# Staff Report

## Raleigh Appearance Commission Administrative Alternate Request

**Case File / Name:** AAD-6-20 – 518 W Cabarrus Street

**Request:** The applicant requests administrative alternates for UDO Sections 1.5.6. Build-To, 1.5.8. Pedestrian Access, and 1.5.9. Transparency.

S. WEST STREET ELEVATION

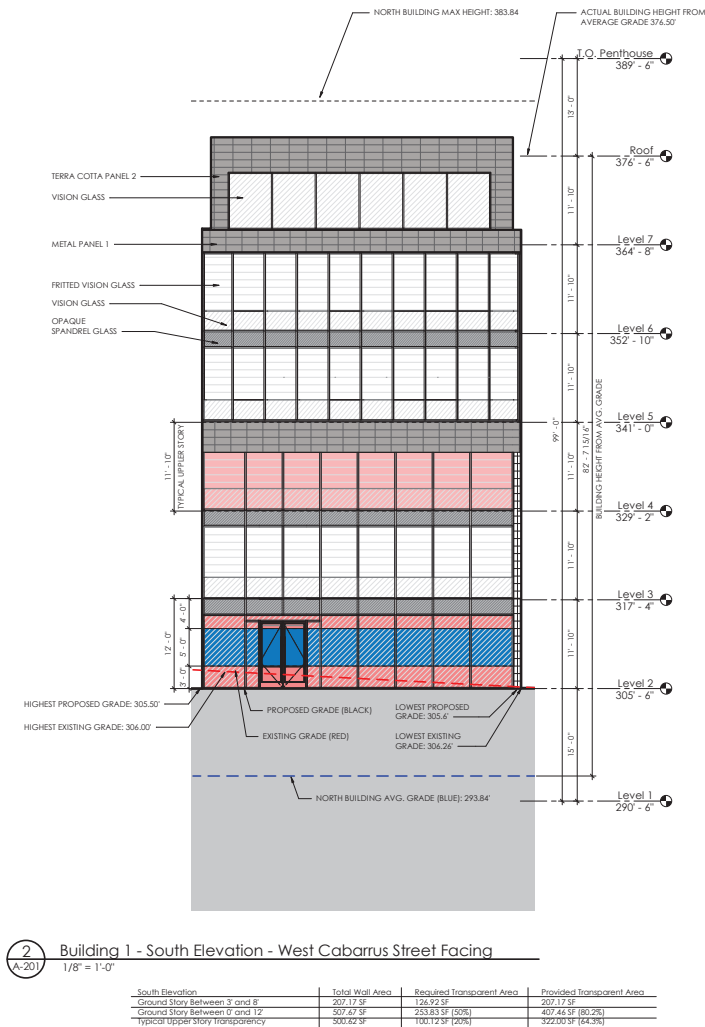
The applicant is requesting an alternate for Transparency for the two office mixed-use buildings on the eastern portion of the site. According to the plans provided by the applicant the proposed ground floor transparency for the southern building along W Cabarrus Street is 40.7%. For the ground floor of the northern building fronting S West Street 19.2% transparency is proposed, with only 23% between 3 and 8 feet. The application does not provide detail as to what architectural features provide visual interest to offset the reduction in transparency.

W. CABARRUS STREET ELEVATION

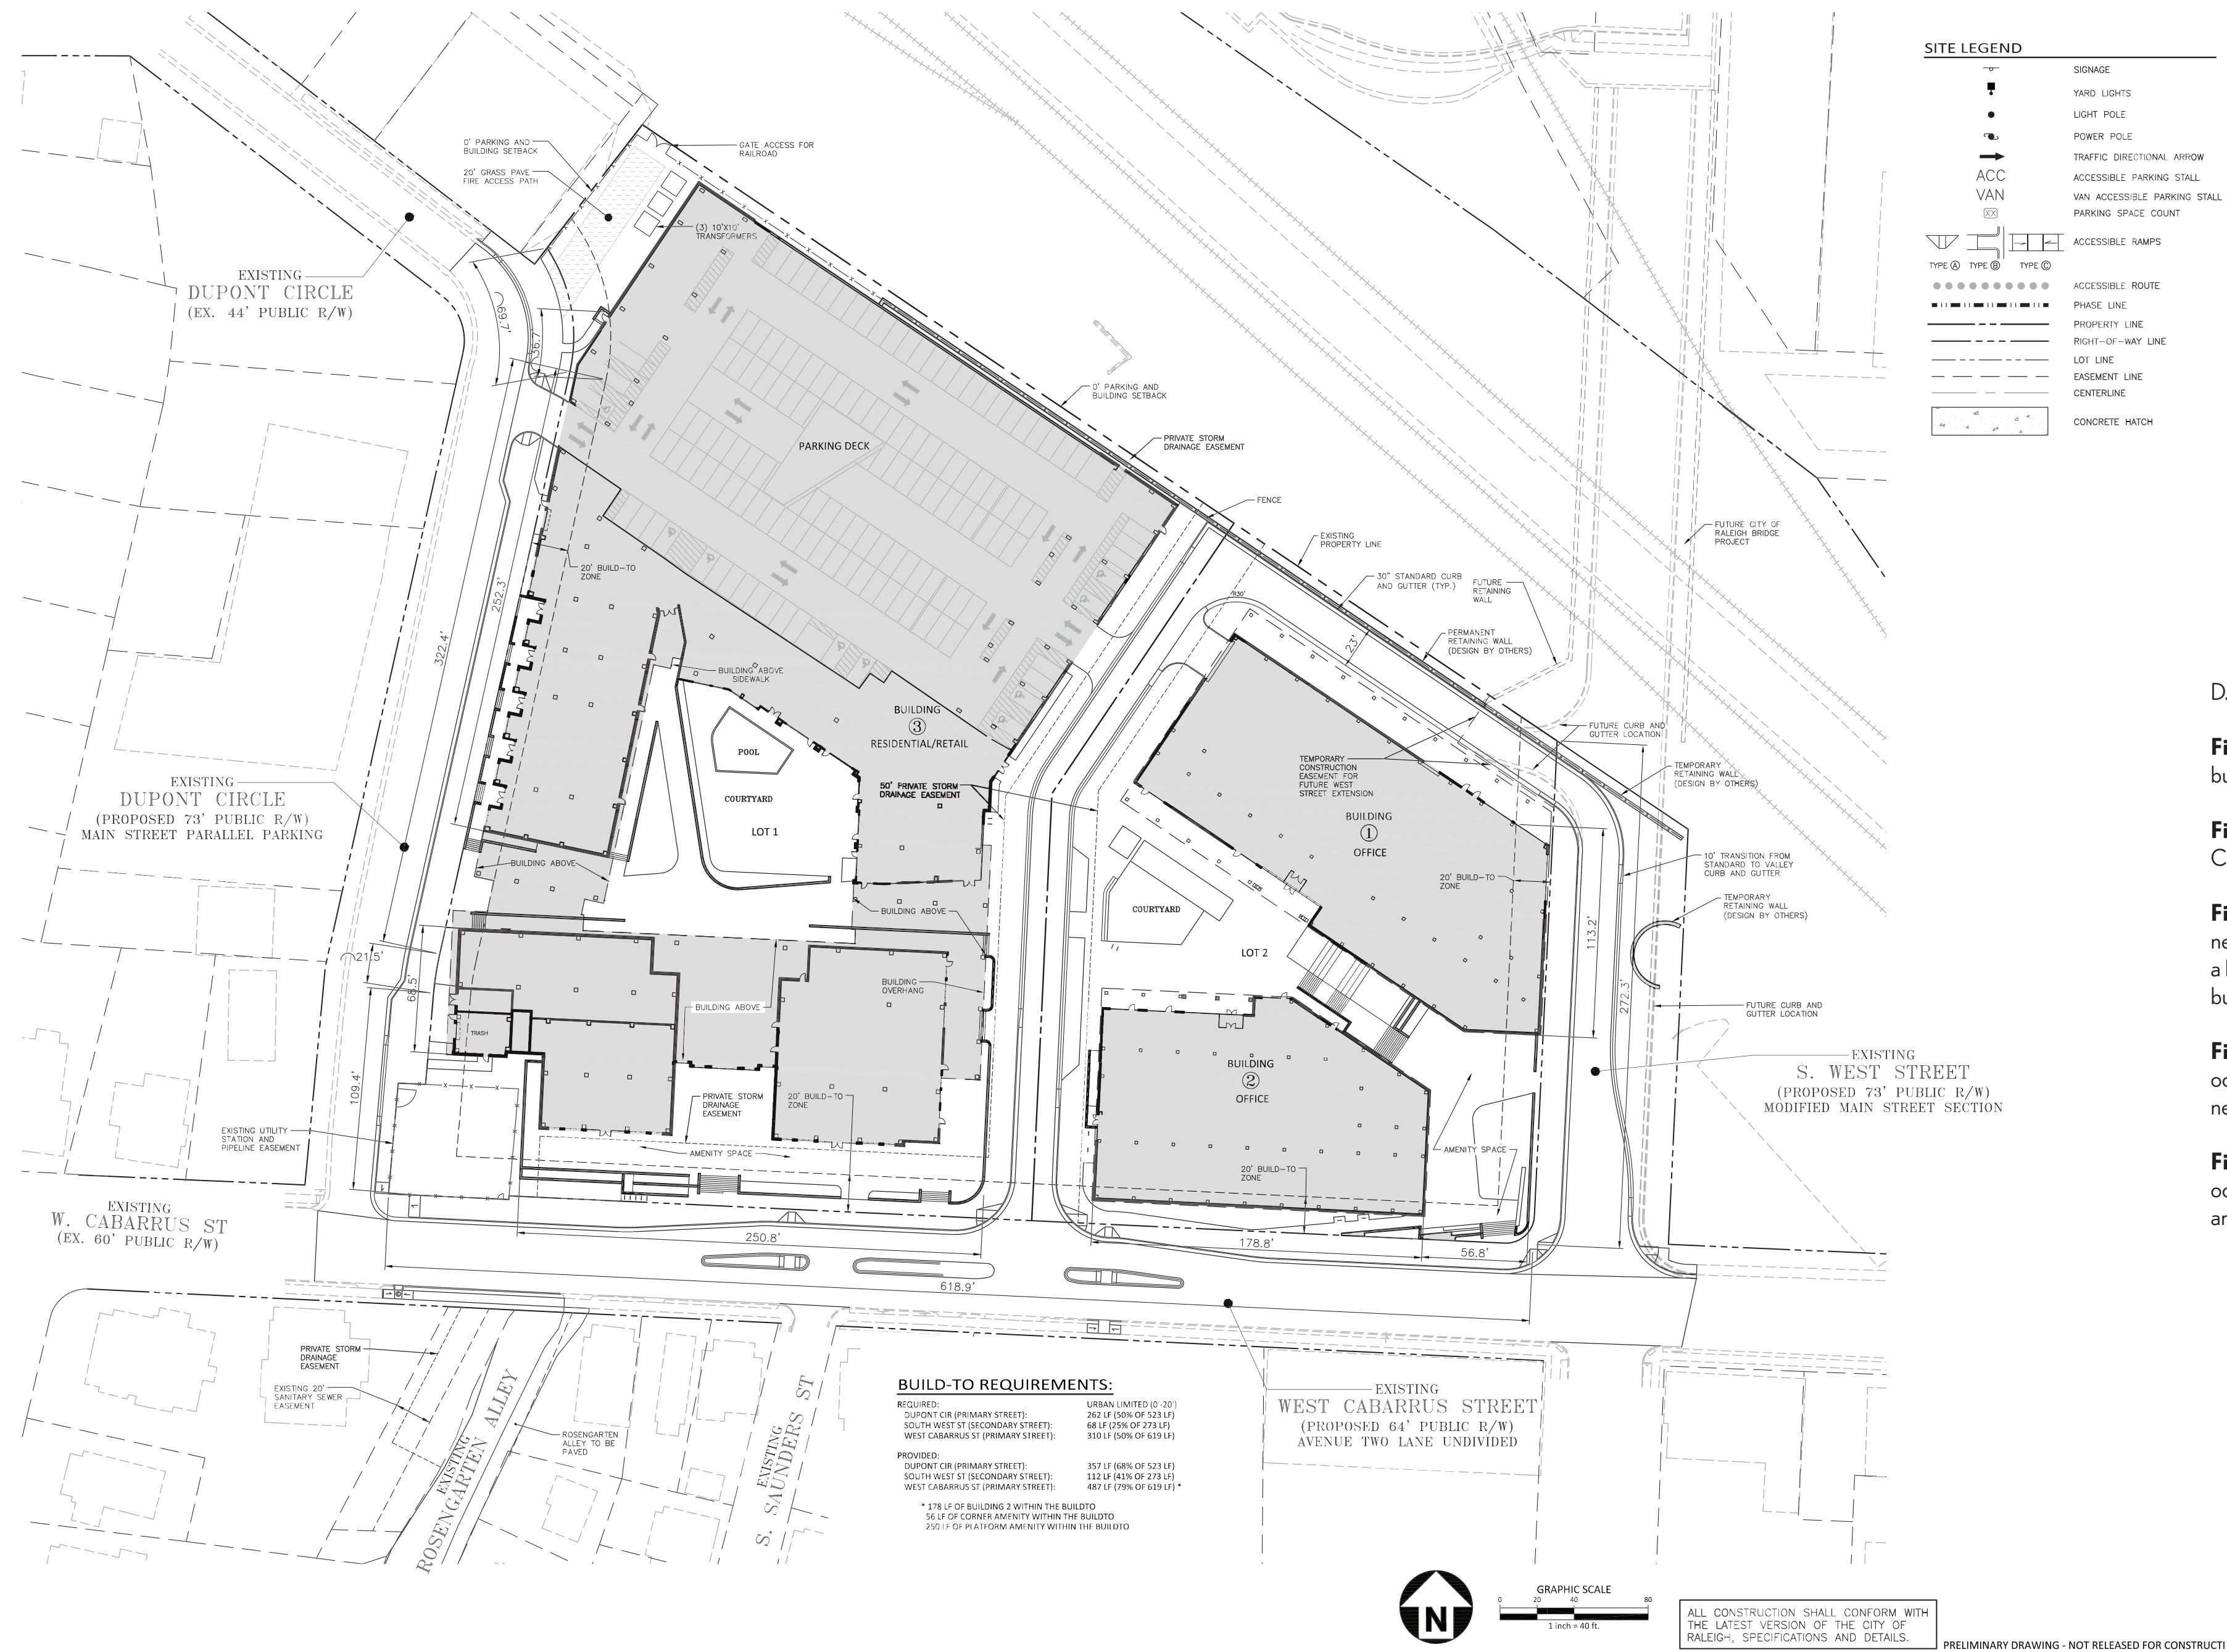
It is important to note that due to a recent UDO text change the method for measuring qualifying ground floor elevation and calculating transparency for it has changed. According to the revised text, the minimum percentage of windows and doors that must cover a ground story facade is measured above the adjacent sidewalk surface of the finished ground floor for all above-grade portions of the

façade. More than a minimum of 50% of the required the transparency must be located between 3 and 8 feet of the building façade from the surface of the finished ground floor. The applicant has been informed of this recent text change but has not submitted revised plans or elevations calculating the transparency with this method.
